**Engineering Works to Form New Eastern Inner Dock Quay, Port of Nigg - Marine Construction Licence (MS-00010859)  
Request for Variation [Doc. Ref 16012 Issue 1]**

# MARINE CONSTRUCTION LICENCE VARIATION APPLICATION

**Title**  
New Site Boundary

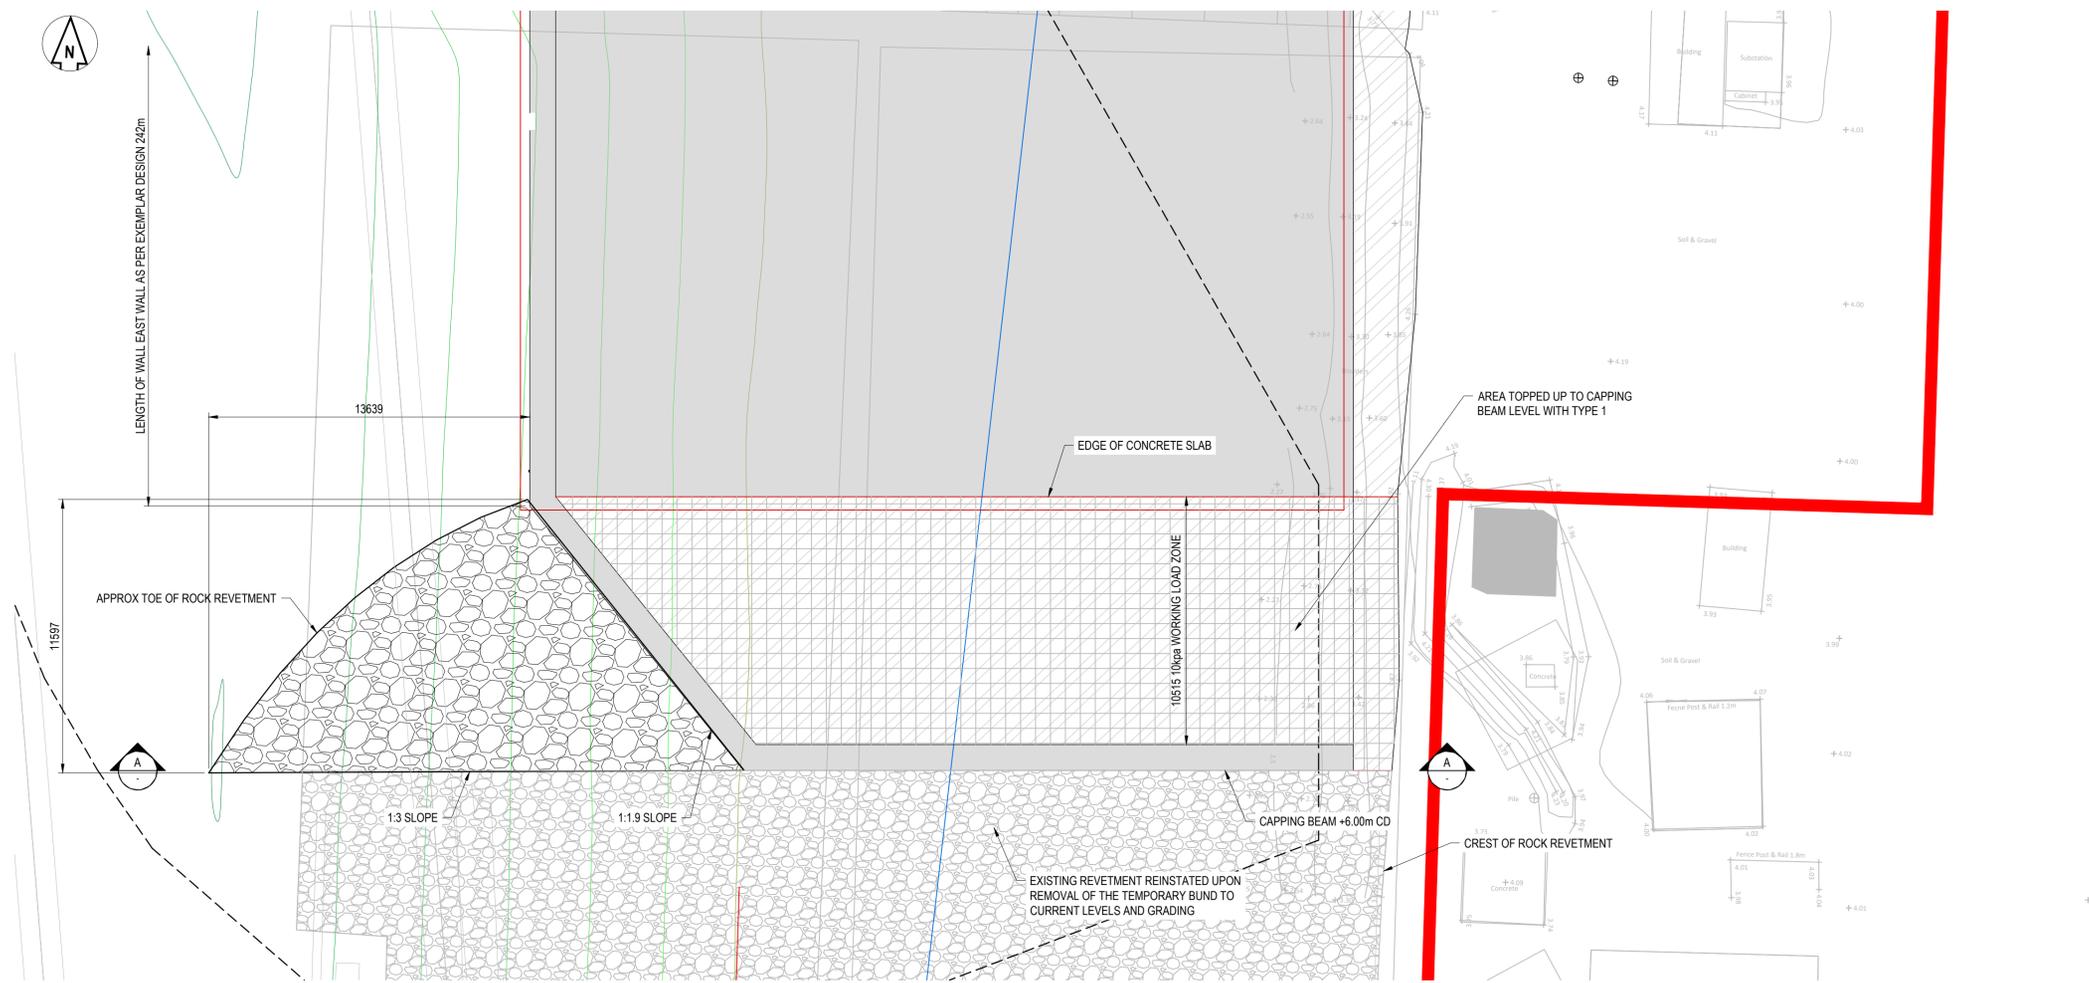
5. The project is subject to a design and build contract, and as such, as part of the detailed design stage, an alteration to the existing site boundary is required to allow for changes to the layout of the works and associated boundary detailed on the existing licence. The changes required to allow for the inclusion of the changes to the bunds associated with the temporary works. The new coordinates required to achieve this boundary are detailed below. The alternation is a slight adjustment to the existing site boundary, as shown in the Appendix **Error! Reference source not found.**. This will result in less than 1% increase in the site area from 23,284 m<sup>2</sup> to 23,380 m<sup>2</sup> associated with the temporary works element only, bund to facilitate piling, and does not impact the footprint of permanent elements of the construction project. The original and the proposed site boundary point coordinates are provided in Table 1 below.

S/N	Original Coordinates		Revised Coordinates	
	Latitude	Longitude	Latitude	Longitude
1	57° 41.793' N	04° 01.511' W	57°41.697'N	004°01.540'W
2	57° 41.857' N	04° 01.519' W	57°41.704'N	004°01.563'W
3	57° 41.884' N	04° 01.608' W	57°41.824'N	004°01.577'W
4	57° 41.864' N	04° 01.641' W	57°41.832'N	004°01.627'W
5	57° 41.830' N	04° 01.637' W	57°41.857'N	004°01.635'W
6	57° 41.827' N	04° 01.581' W	57°41.885'N	004°01.614'W
7	57° 41.792' N	04° 01.576' W	57°41.871'N	004°01.598'W
8	57° 41.740' N	04° 01.570' W	57°41.866'N	004°01.579'W
9	57° 41.702' N	04° 01.565' W	57°41.867'N	004°01.514'W
10	57° 41.700' N	04° 01.520' W	57°41.706'N	004°01.506'W

Drawing Title  
SOUTHERN RETURN WALL  
ROCK REVIEMENT

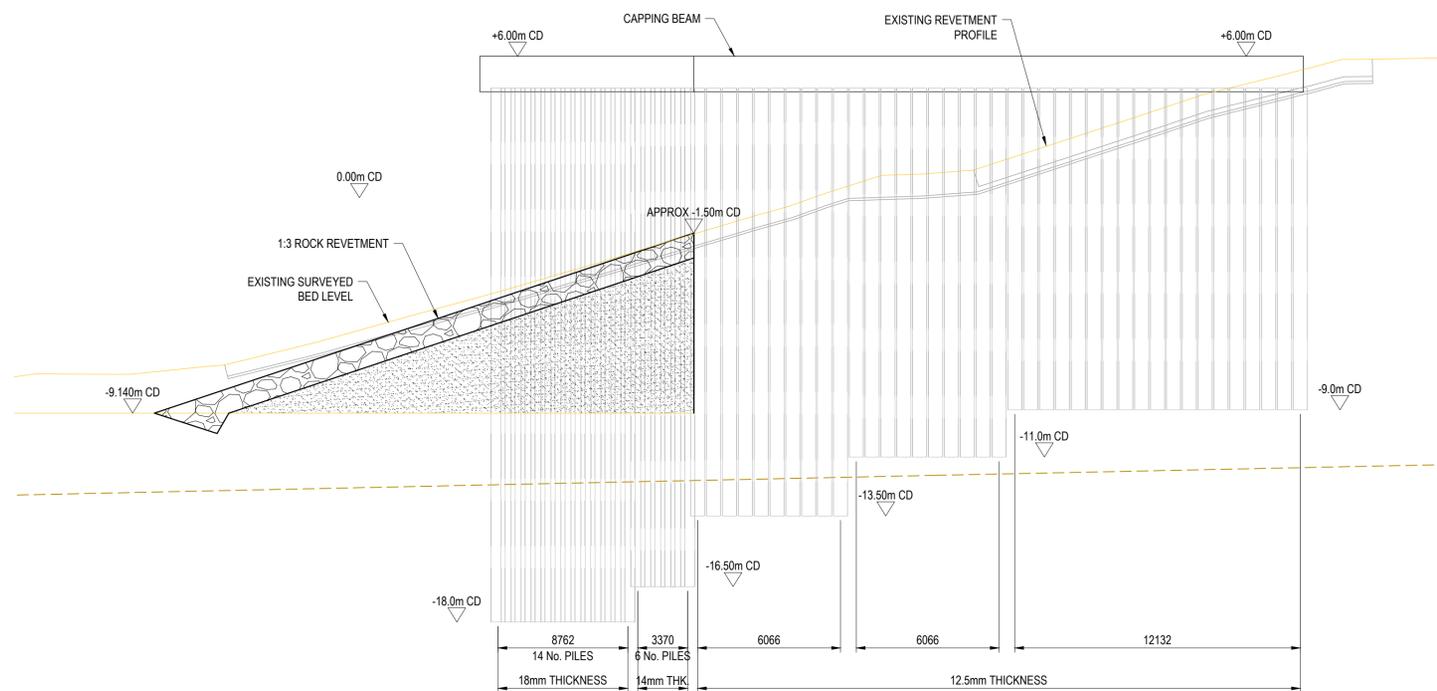
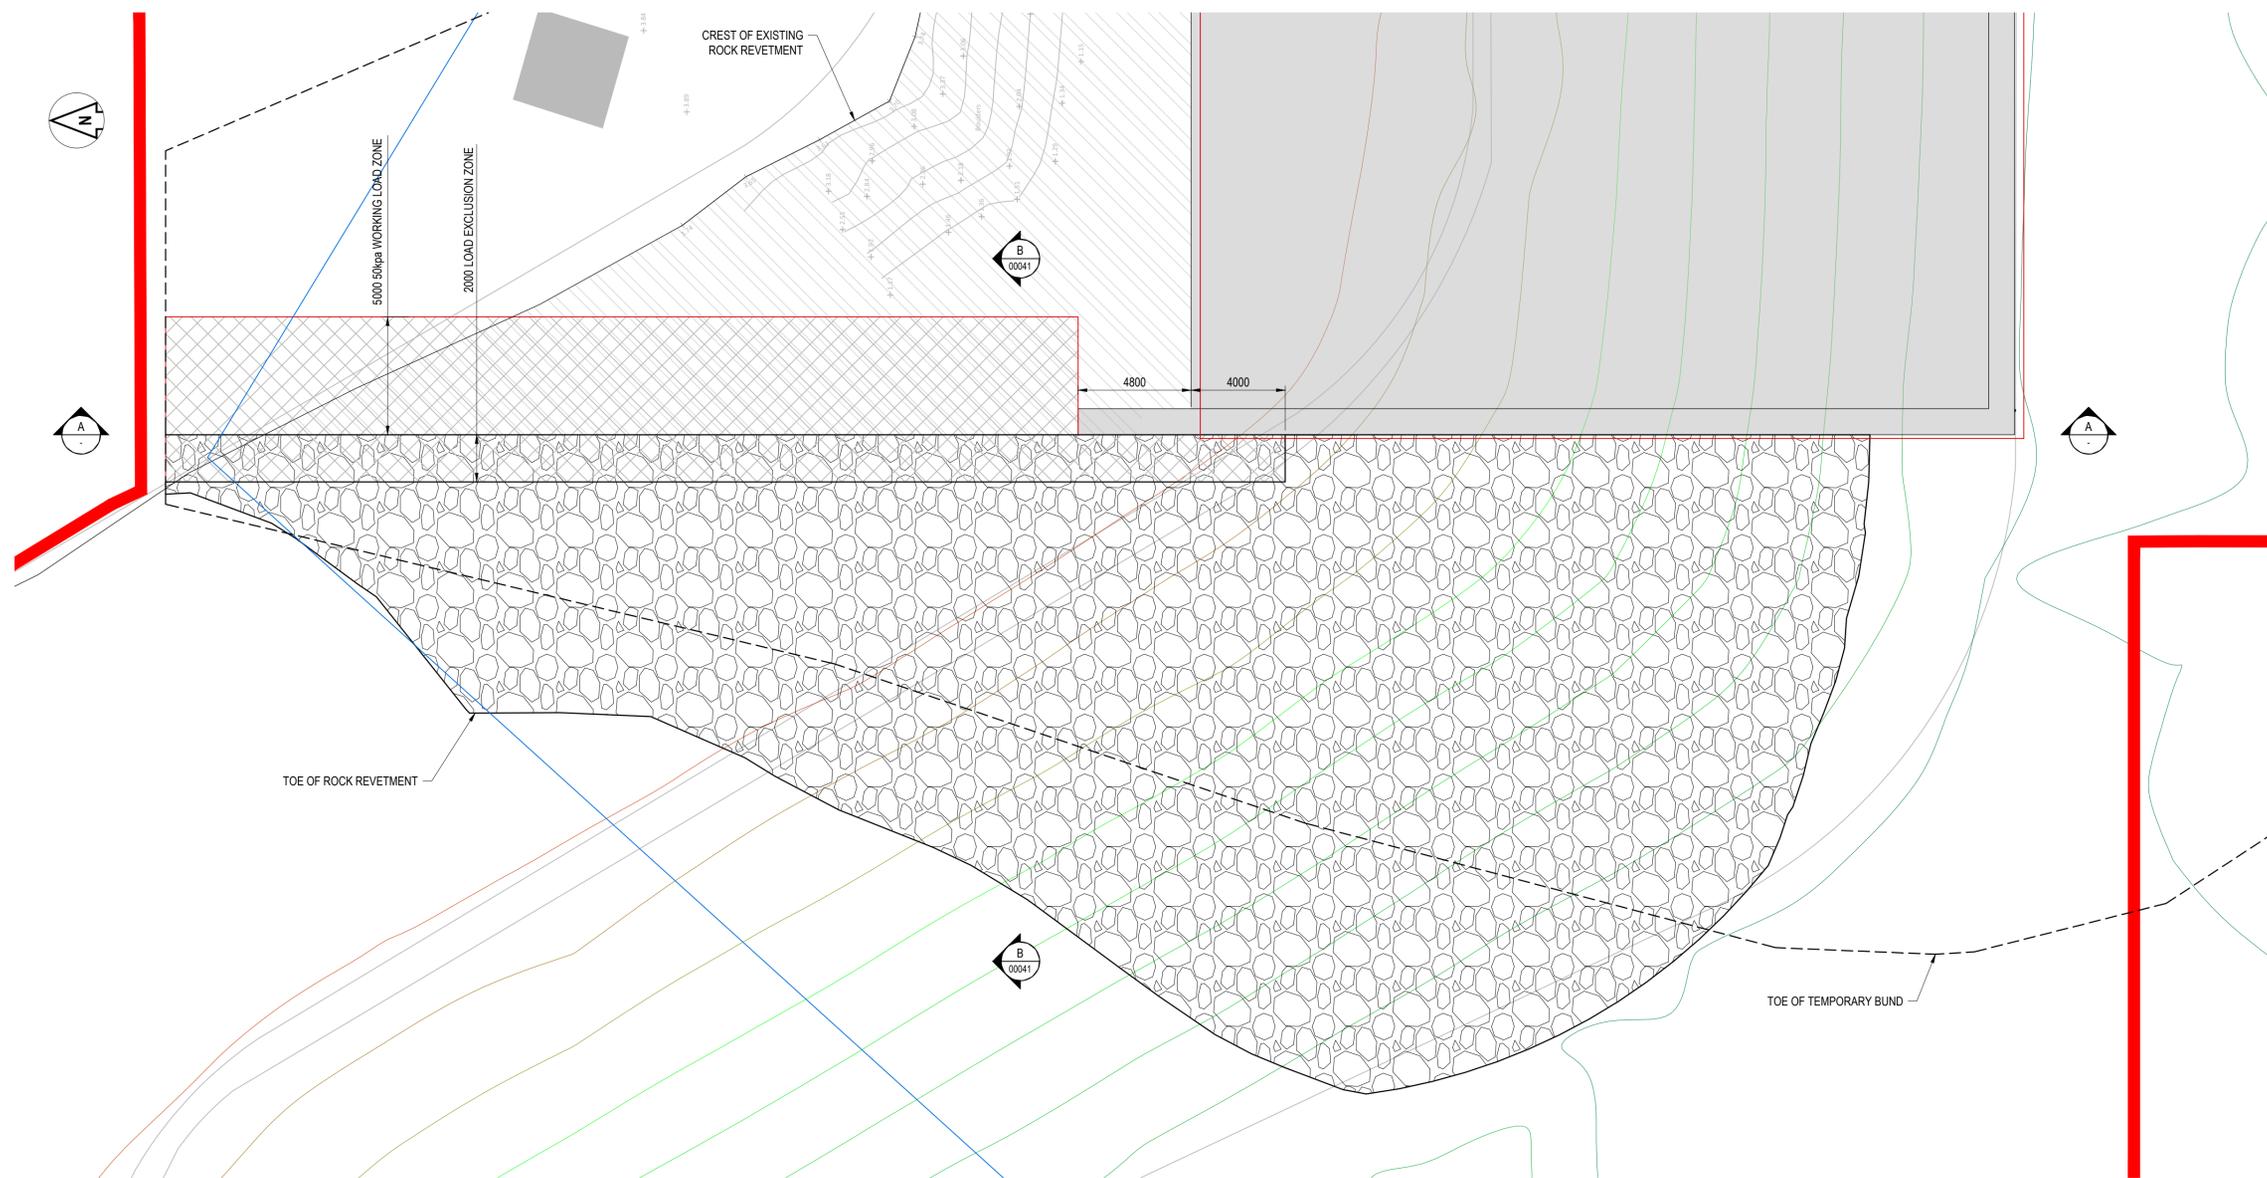
6. The requirement for inclusion of rock armour at both ends of the quay are for the following purposes:
  - Placement of rock armour on the southern return of the quay is to reinstate the existing rock armoured side slope, which will need to be disturbed as part of the development; and

8. It is planned that some of the crushed rock and stone will be reused for the construction of rock armour at both ends of the quay as detailed in the accompanying drawings EIDQ-RWC-00-XX-DR-C-00004, EIDQ-RWC-00-XX-DR-C-00040, EIDQ-RWC-00-XX-DR-C-00045.

Drawing Title  
NORTHERN RETURN WALL  
ROCK REVETMENT

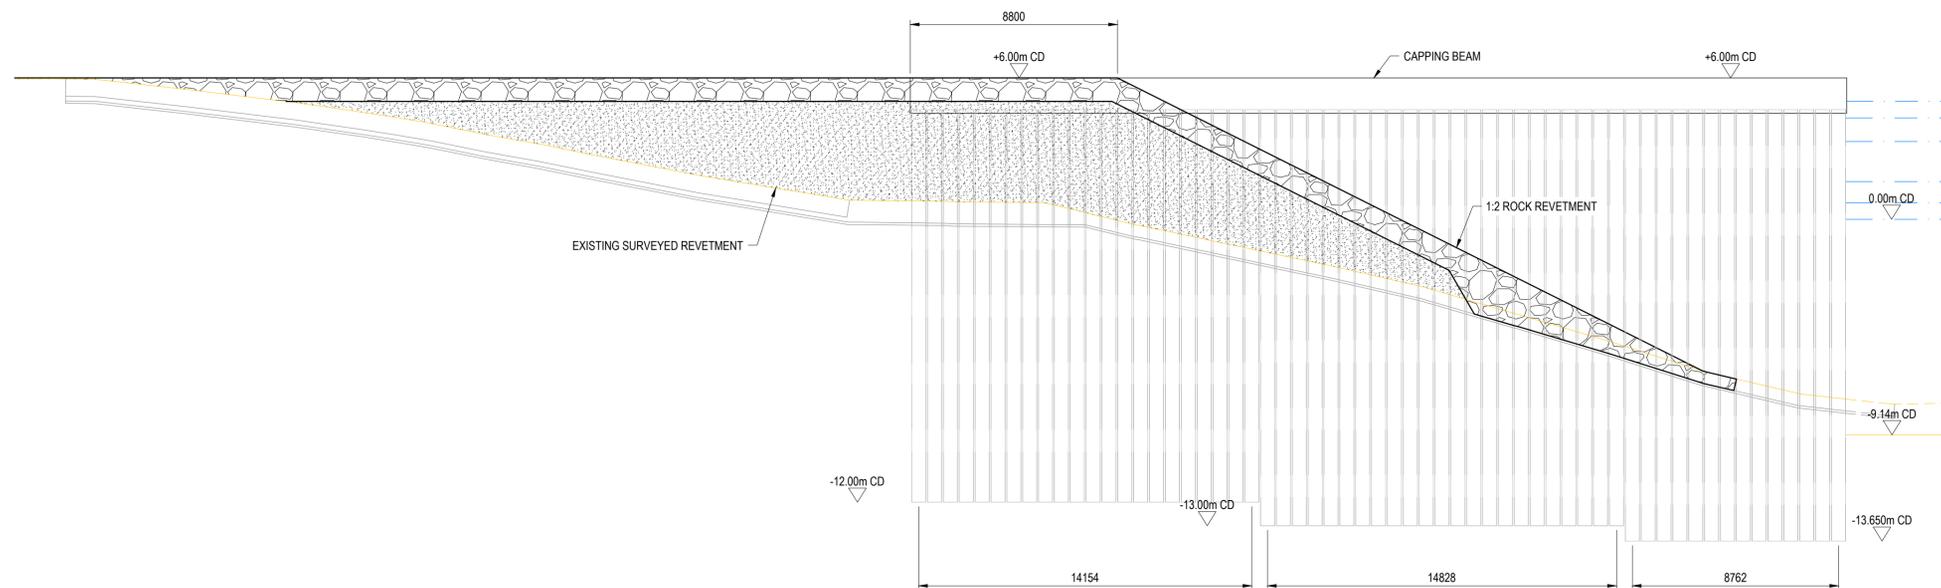
- The rock revetment on the north return is to be formed to provide passive resistance and stability of the infill of the working platform. This will be constructed from a stone core and protected from wave and tidal erosion with the recovered rock armour on the outer faces.
